SERIAL: BSEP 02-0016
TSC-2001-04

BRUNSWICK STEAM ELECTRIC PLANT, UNIT NOS. 1 AND 2
DOCKET NOS. 50-325 AND 50-324/LICENSE NOS. DPR-71 AND DPR-62
RESPONSE TO REQUEST FOR ADDITIONAL INFORMATION - REQUEST FOR
LICENSE AMENDMENTS TO ADOPT ALTERNATIVE RADIOLOGICAL SOURCE
TERM (NRC TAC NOS. MB2570 AND MB2571)

Response to Request For Additional Information (RAI) AST 3

BSEP Unit 1: Main steam drain line and spring and strut supports in the Reactor Building MSIV pit.

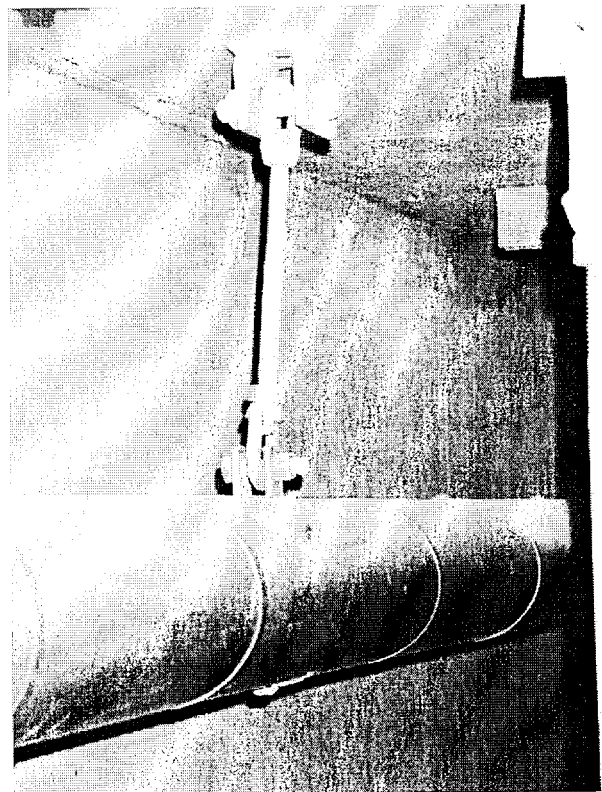
In discussion under NRC limitation 2, you stated that the design attributes of the BSEP piping and supports were compared to the attributes of the database piping and supports as shown in Tables 4-3 through 4-6. The referenced tables do not show any comparison of design attributes of the database piping supports with the BSEP piping supports. Provide a comparison that was performed for piping support attributes. For the most critical pipe support, provide a basis for the selection of the governing support and summary of seismic load calculation, load combination, and method of analysis considered in the evaluation. Also, provide a summary of evaluation results including the maximum calculated stress, allowable stress, Code, and Code Edition used for evaluating the most critical components.

For pipe support comparisons, refer to Section 4.3 of the enclosure to CP&L's submittal dated September 27, 2001 (Serial: BSEP 01-0112), which describes the earthquake experience-based approach to review the design attributes of the BSEP piping and related supports in order to demonstrate that they fall within the bounds of the experience database. Briefly stated, the Brunswick ALT piping systems consist of welded steel pipe and standard support components. Typical standard support components utilized at BSEP include single rod hangers or rod-hung trapezes, variable spring hangers, and welded steel angle trapezes or cantilever brackets with U-bolts. Some typical BSEP pipe support configurations are shown in the following figures.
